IN THE MATTER of proposed Plan Change G: Aokautere Urban
Growth to the Palmerston North City Council
District Plan

**STATEMENT OF REPLY EVIDENCE OF HARRIET FRASER ON BEHALF OF PALMERSTON NORTH
CITY COUNCIL**

TRANSPORTATION

Dated: 28 November 2023

Figure 3: Aokautere Dr – Pedestrian Refuge Concept with Reduced Crossing Distance

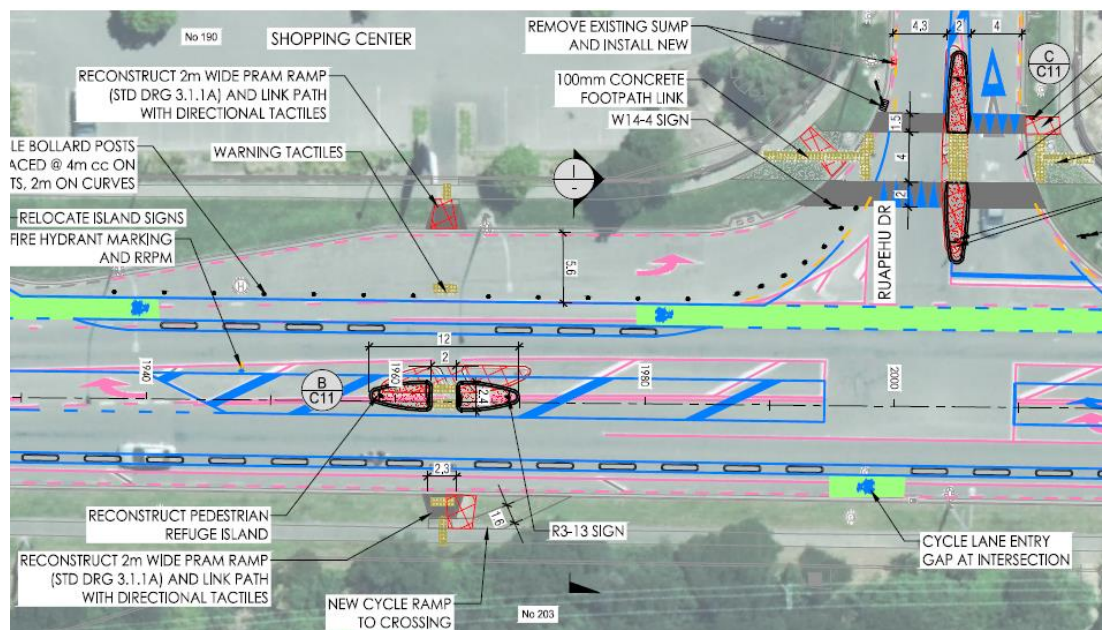
4. The Transport Choices project as per the recommendation of the Safe System Audit, suggests the left turn slip lane into Ruapehu Drive is removed providing an opportunity to narrow the crossing width for pedestrians. Figure 3 below shows the progressed detail design for this treatment. The traffic lanes will have a width of 3.2-3.4m and Mr Connelly has requested consideration be given to a refuge islands being included between the traffic lanes and cycle lanes such that pedestrians can cross the cycle lane and traffic lane in two stages. A perspective of the treatment is shown in Figure 4.

Figure 5: Mid-block Crossing Facility Selection Flowchart - [Pedestrian Network Guidance](#)

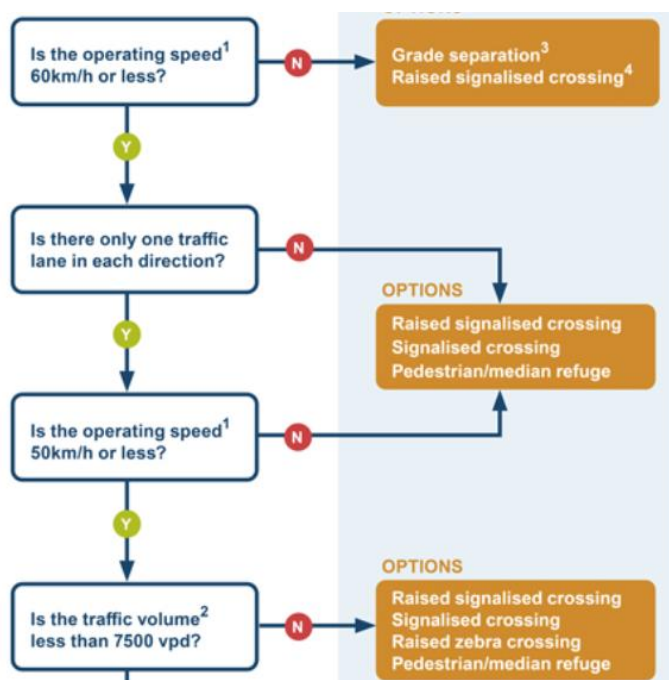
5. The Waka Kotahi Pedestrian Network Guidance includes a mid-block crossing selection flowchart. Included below is the upper portion of the flowchart which applies to crossings on roads carrying more than 7,500vpd.

6. Using this flowchart results in the following fundamental crossing options, depending on the speed limit on SH57 Aokautere Drive:
 - a. 70km/h - the existing speed limit,

either grade separated or a raised signalised crossing;

- b. 60km/h - the identified Safe and Appropriate Speed for the existing context, raised signalised crossing or signalised crossing or pedestrian/median refuge; and
- c. 50km/h – the potential future speed limit, as per 60km/h but with added option of a raised zebra treatment.

Figure 6: Mean waiting delay for pedestrians crossing at various facilities on a two-lane, two-way urban road (uninterrupted flow) - [Pedestrian Network Guidance](#)

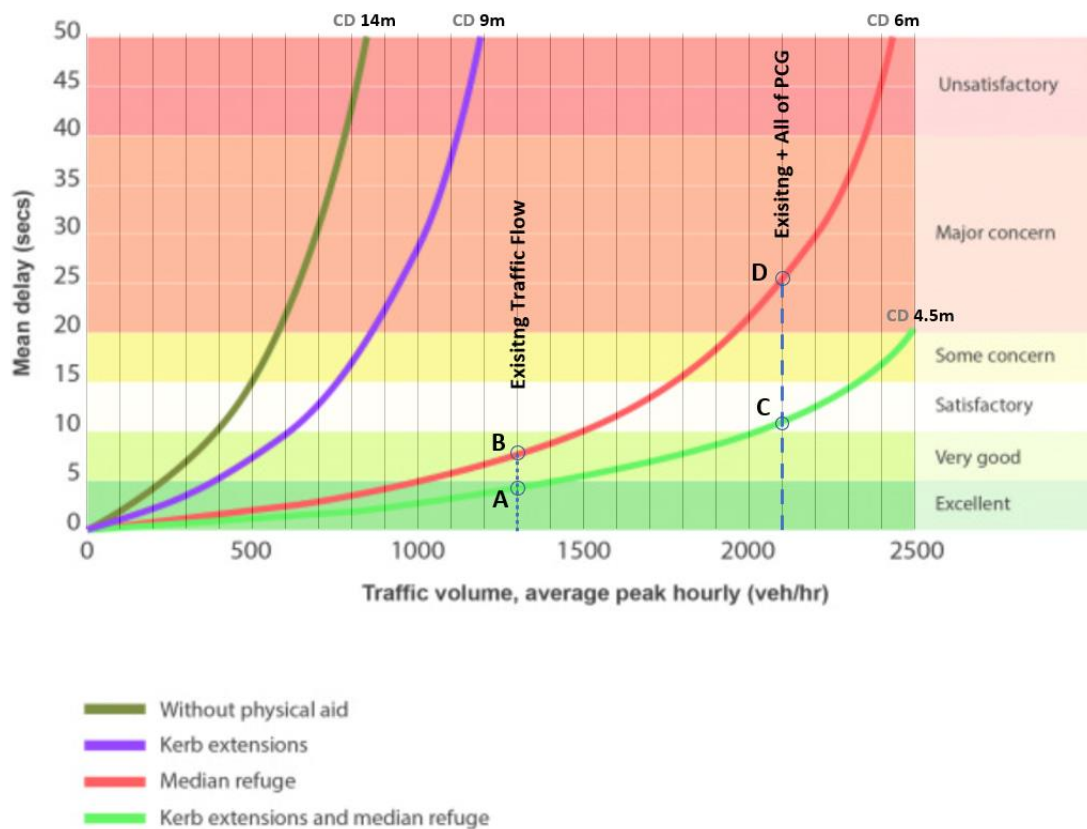
8. The existing peak hour traffic flows on this section of SH57 Aokautere Drive are around 1,300vph both ways (Figure 6 - Points A and B), and with the PCG area fully developed are forecast to increase to around 2,100vph (Figure 6 - Points C and D). The indication is that a crossing with a median refuge and crossing distances of 6m or less each side would perform well (Figure 6 - Points A and B within the 'very good' or 'excellent' categories) in terms of pedestrian delay with the existing traffic volumes of 1,300 vph. With the additional traffic flows from PCG and flows of 2,100 vph on Aokautere Drive, the width of the crossing distances becomes critical as the pedestrian delay would escalate and become a 'major concern' with pedestrians having to cross 6m of carriageway (Figure 6 - Point D). A crossing distance of closer to 4.5m would be needed for the delay to be considered 'satisfactory' (Figure 6 - Point D). At this stage crossing distances of less than 4.5m look to be achievable in the vicinity of the Summerhill Shopping Centre. It should also be noted that this guidance is for a 50km/h speed environment with a more conservative position needed if the speed limit is 60km/h.

9. On the basis of the information included in the Pedestrian Network Guidance and the assessment above, we are comfortable that assuming that there is a speed limit reduction to 60km/h or lower, and that the pedestrian crossing distances either side of a refuge are kept to as close to 4.5m as possible, that a median refuge treatment can provide for pedestrians until such time as the nearby intersections are upgraded and provide for improved crossing facilities in those locations. It is also noted that within a 50km/h speed environment, there is an option to introduce a raised signalised intersection or raised zebra crossings which would provide a

Figure 8: Concept Design for Right Turn Cycle Movements into Side Roads

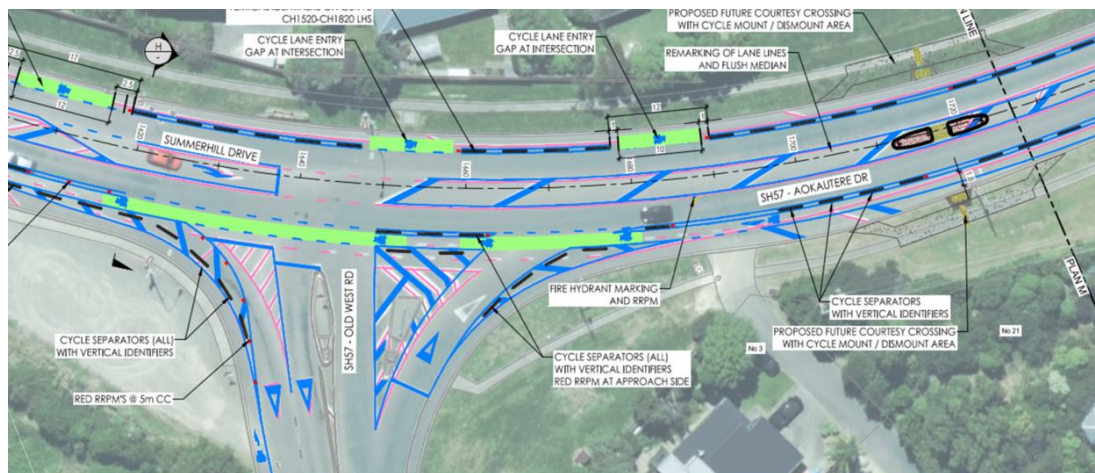
12. An alternative treatment, as illustrated in Figures 8 and 9, includes the positioning and use of a median refuge a short distance beyond the intersection to support less confident cyclists. This would allow right turning cyclists to make a right turn in two stages crossing each stream of traffic separately as per Figure 9. These figures illustrate a concept design at the Old West Road SH57 intersection with similar designs possible at the Pacific Drive and Johnstone Drive intersections with SH57.

Urban Connector F (7A.4D 6)

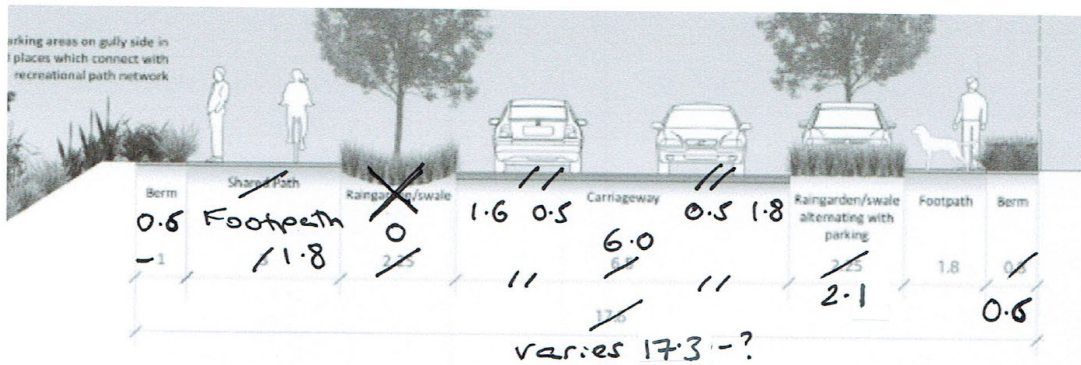
- [20] As shown, the changes in the legal width of the streets as a result of the proposed amendments are small with the exception of Urban Connector F. As a result of the

inclusion of on-road cycle lanes and associated buffers, the cross-section width for this street typology increases by 1.5m. The cross-section for Urban Connector Roads F would become the same as that for Urban Connector Roads B. I recommend that the Urban Connector Road F typology be removed and replaced with Urban Connector Road B.
